Low-Level Liquid Radioactive Waste Treatment at Murmansk, Russia: Technical Design and Review of Facility Upgrade and Expansion

**LOW-LEVEL LIQUID RADIOACTIVE WASTE TREATMENT AT MURMANSK,
RUSSIA: TECHNICAL DESIGN AND REVIEW OF
FACILITY UPGRADE AND EXPANSION**

July 1996

Questions and Answers About the Design of the Low-Level Liquid Radioactive Waste Treatment Facility Rev 4-December 1995

Figure D-2. Proposed LLRW System - Electromembrane Unit - Flow Diagram (continued)

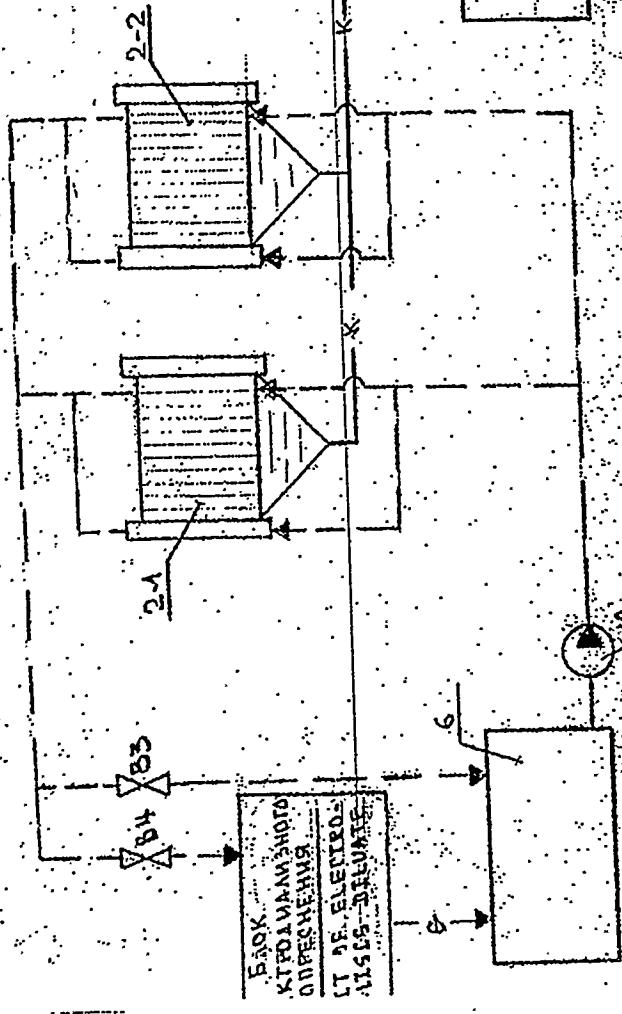
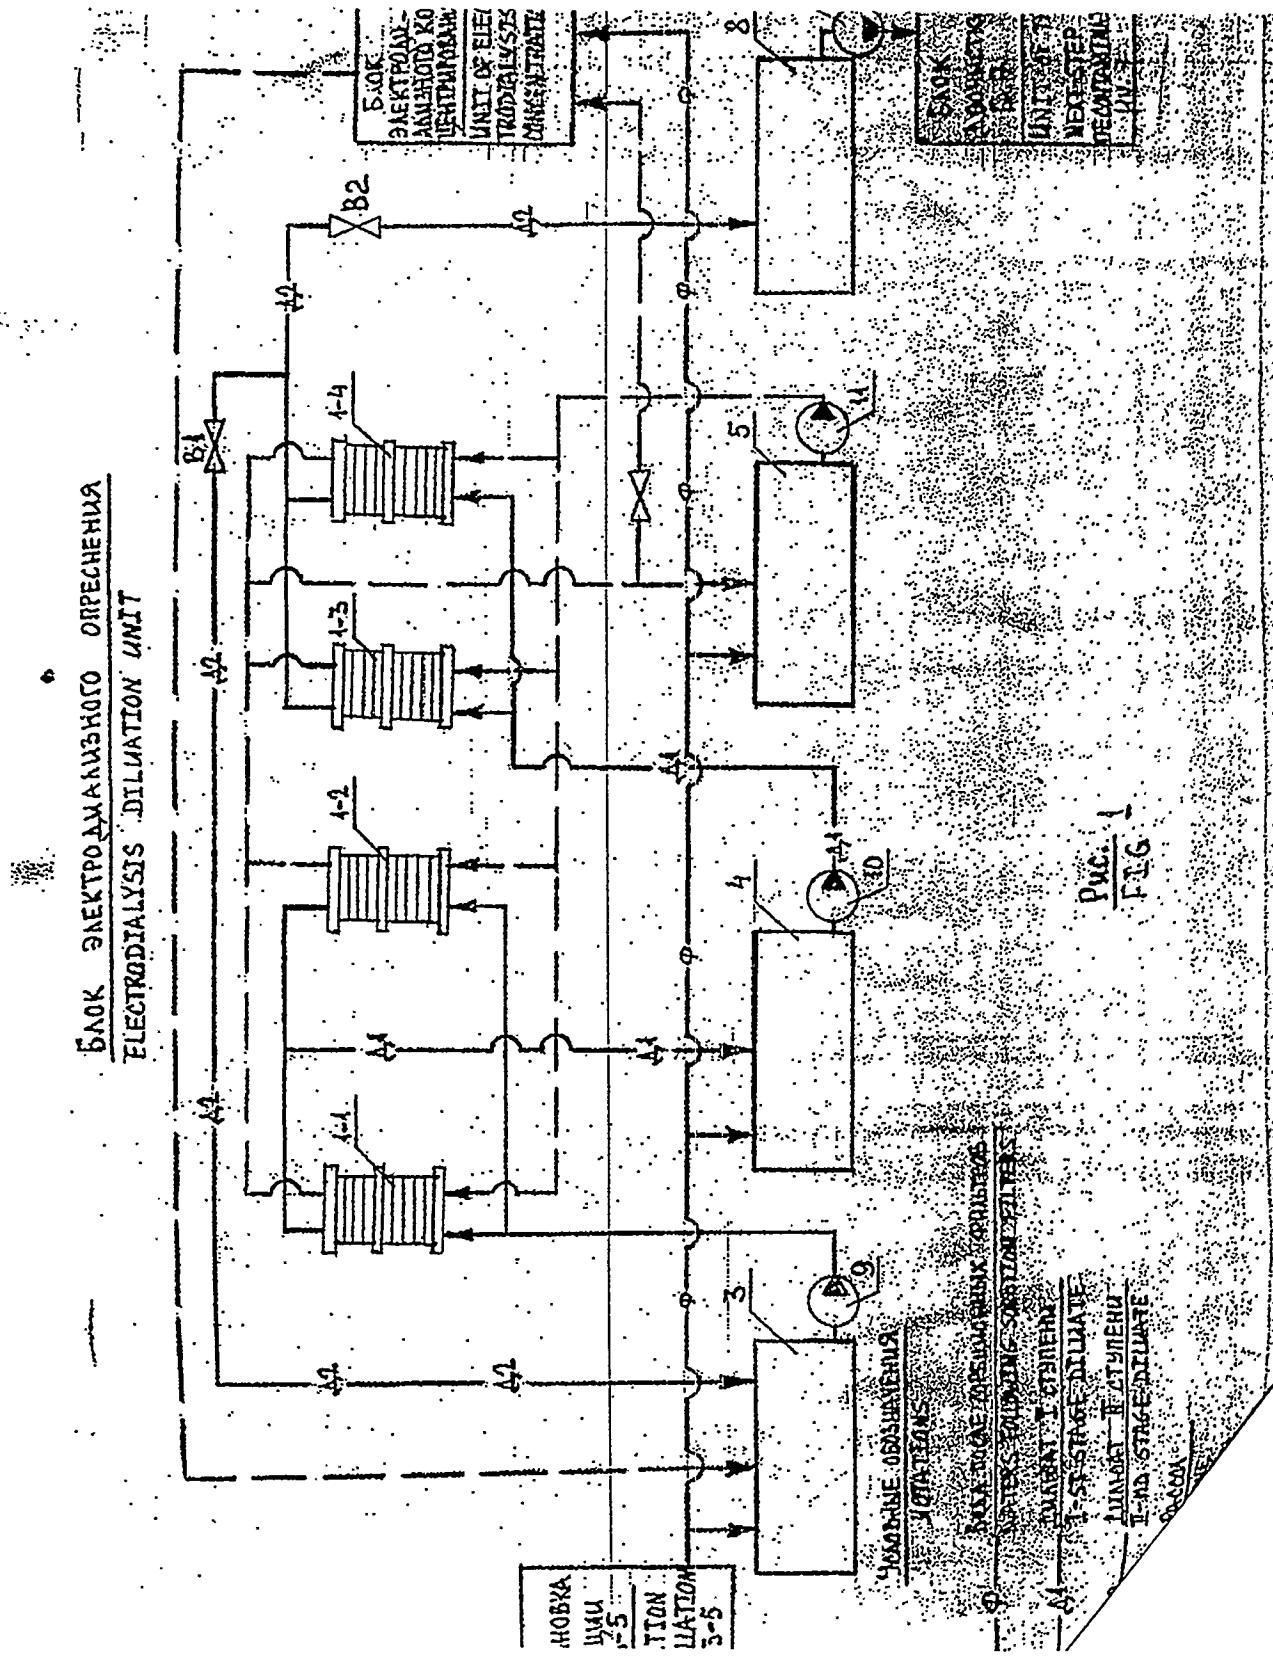
The components of the Electrochemical Unit assembly are those within the rectangle labeled A1-4 (Figure D-1). In reviewing the operation of Unit 1, ASPECT provided a revised flow diagram (Figure D-2).

The electrolysis unit (EM), the device shown at the center of Figure D-2, has multiple chambers separated by "normal" anion and cation exchange membranes where, here, the term "normal" means commonly available. The electrolysis of water from a solution of reagent sodium chloride (NaCl) produces two intermediate streams: one basic (sodium hydroxide - NaOH), and the other acidic (hydrochloric acid - HCl), which are maintained separate from one another using the membranes. As described below, the sodium hydroxide is used to reduce hardness. The acid is removed from Unit 1, and does not re-enter the treatment system, but could, however, be used to adjust the pH of the wastewater at some time.

During the review, it became clear this design concept for adding "fresh" NaOH was expensive, sophisticated, and required significant building space. Thus, alternate processes were also examined and a revised concept based on simple addition of phosphate was developed.

-are the membranes mislabeled in Figure 1? Shouldn't "K" be "A" and "A' be "K" ?

-Figure 1 appears to show four chambers; yet it is identified as a three-chambered cell. Are we misinterpreting the diagram ? Please explain.

-Figure 1 appears to show only three solutions (concentrated NaOH and HCl and NaCl working solution) passing through the electromembrane device; yet drawing 965-817-OP shows five solutions passing through Unit 16. Please explain how Figure 1 corresponds to drawing 965-817-OP. In particular, if drawing 965-817-OP is correct, please revise Figure 1 to show all five solutions. Also, please provide a thorough discussion of the basic principles of operation of the unit which is consistent with the new diagram.

After reviewing cost and space requirements, it is now proposed to add phosphate as the softening process. This is low risk, provided the redesign of the plant does not affect the schedule.

A (ASPECT) Figure 1 above explains how the electrodialysis unit works as part of the Unit 6. Actually, fig.1 for the Unit 1 shows 3 prime solutions, circulating through the electrodialysis Unit for decomposition and these solutions are determinants for the mass balance of the Unit. apart from these supporting streams contributing to the unit efficiency are shown on the drawing 965-8177-OP.

Figure D-4. Proposed LLRW System - New Sorbent Column Design

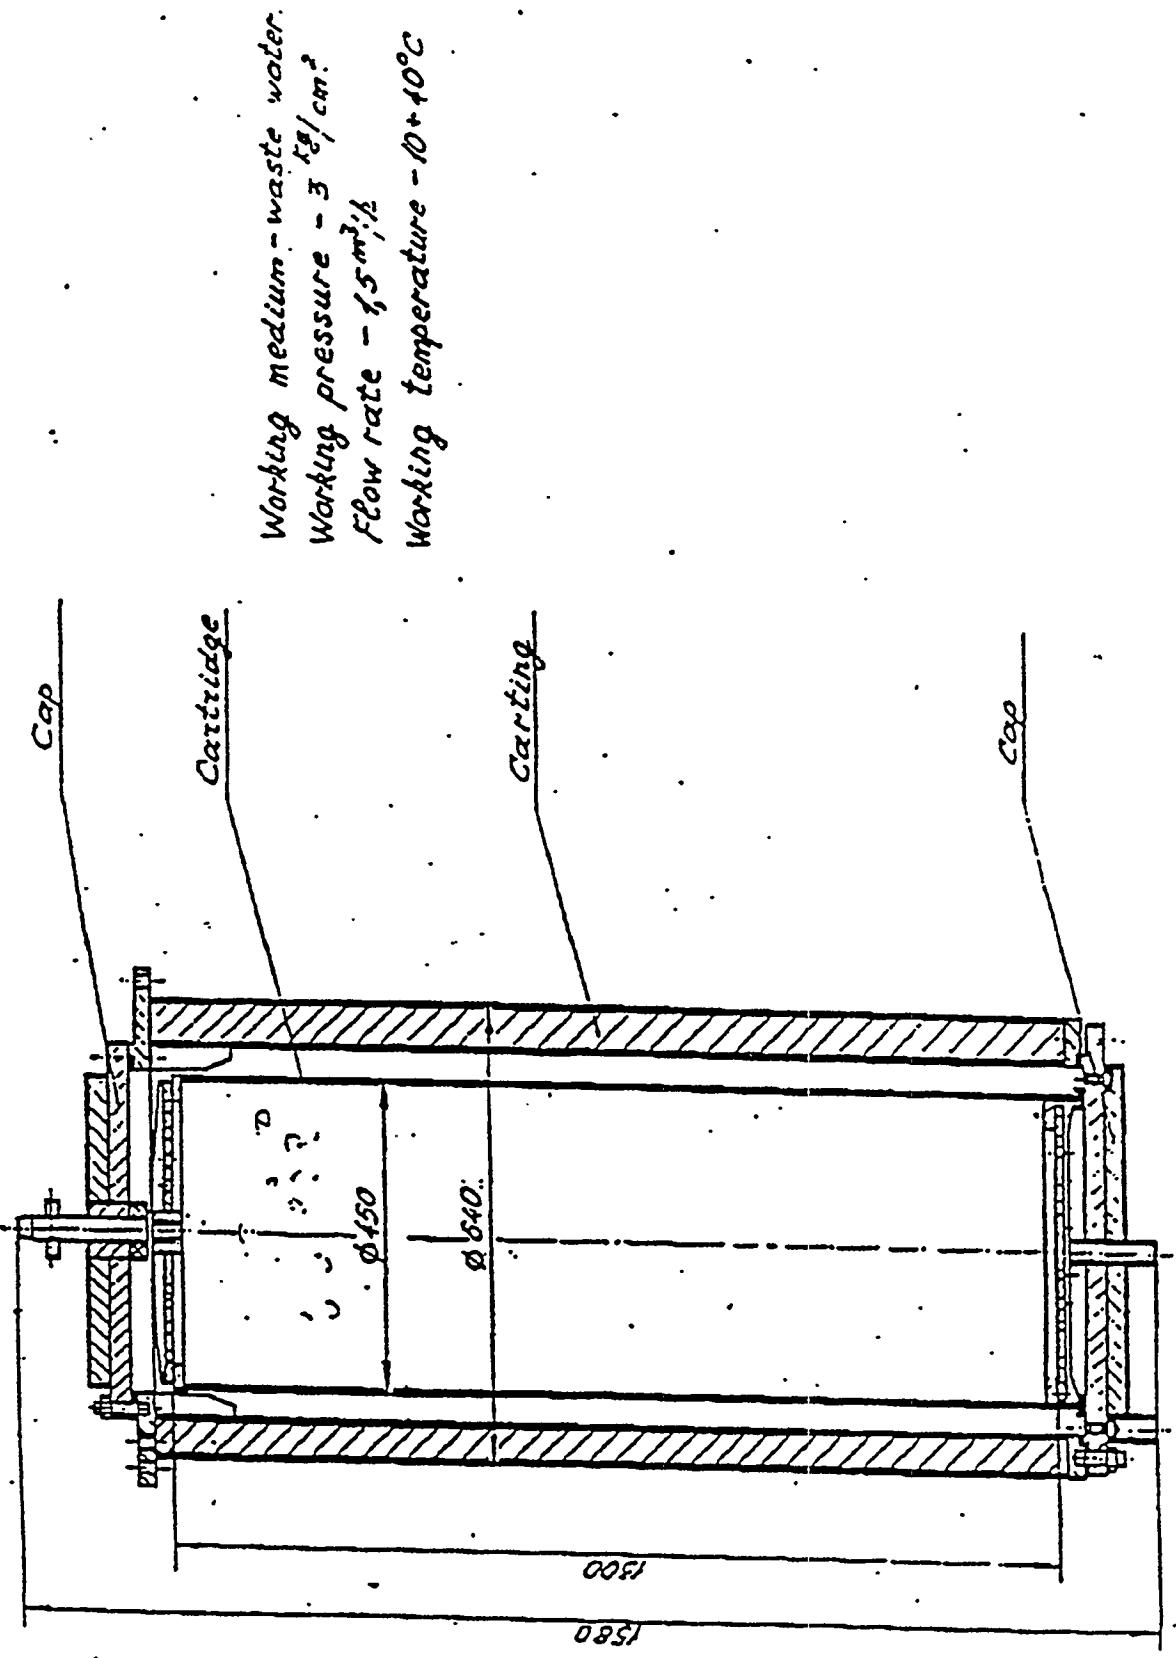
Any newly fabricated vessels required will be of a new design (Figure D-4). These vessels will have sand packed in a more easily removable cartridge. The spent sand cartridge will be removed into a shielded container for transport to storage or to the solidification facility, when its design is modified to process such wastes.
